_Date: 03-10-94 11:03:20 PM
_To: ata@dt.wdc.com@internet
_Cc: ata review
_Recipient: ata@dt.wdc.com@internet
_From: Hale Landis@SEAGATE
_Subject: Power Management Description Cleanup = 94-064r1

Power Management Description Cleanup

Document 94-064r1

Figure ?. Power Management Modes

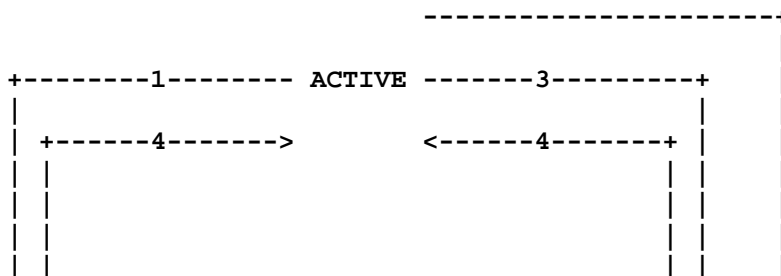
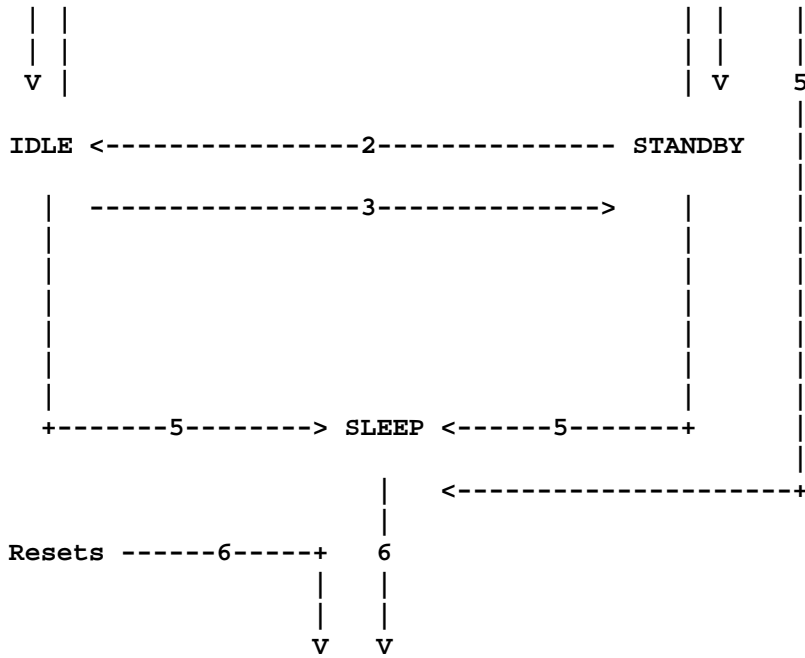
Figure ? shows the minimum set of mode transitions that shall be implemented.

(see Path 6)

- Path 1: An Idle command, Idle Immediate command or vendor unique implementation moves the drive to Idle mode.
- Path 2: An Idle command or Idle Immediate command moves the drive to Idle mode.
- Path 3: A Standby command, Standby Immediate or Standby timer expiration moves the drive to Standby mode.
- Path 4: A Media access command moves the drive to Active mode.
- Path 5: A Sleep command moves the drive to Sleep mode.
- Path 6: A reset, either hardware or software, moves the drive to Active, Idle or Standby as specify by the drive vendor.
